Determination 2017/014

Regarding a building consent for the recladding of apartments at 10-14 Hobson Street, Auckland

Figure 1: West and South elevations indicating Areas referred to in Table 5 above

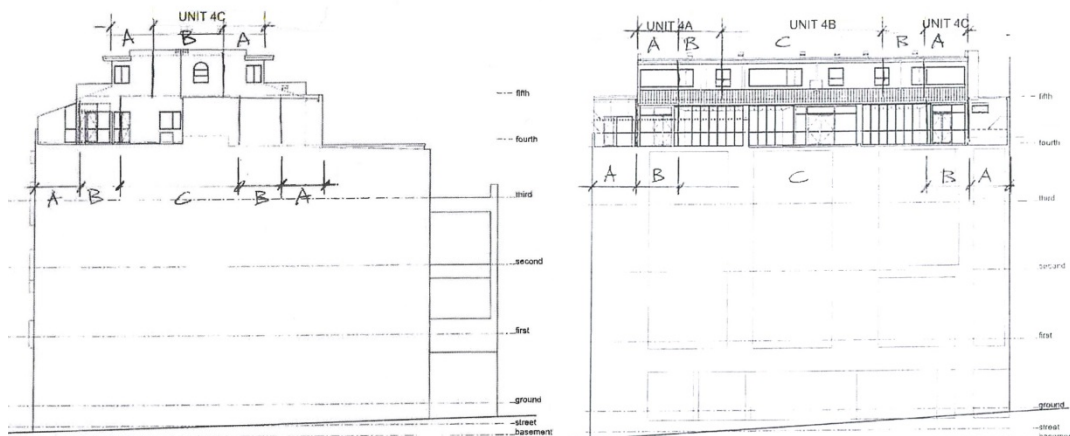
6.5.3 The expert recalculated the maximum wind pressures using an internal coefficient of zero that resulted in reduced negative design pressures (-1.3kPa (ULS) and 0.88kPa (SLS)), which were within all maximums specified in the appraisal Certificate for the cladding system.

6.5.4 In contrast to the second engineer's values shown in Table 3 (see paragraph 3.5.2), I note that the expert's calculations in Table 5 show the highest values for both positive and negative wind pressures apply to external walls of apartments 4B and 4C on the south and west elevations, which are to be re-clad.
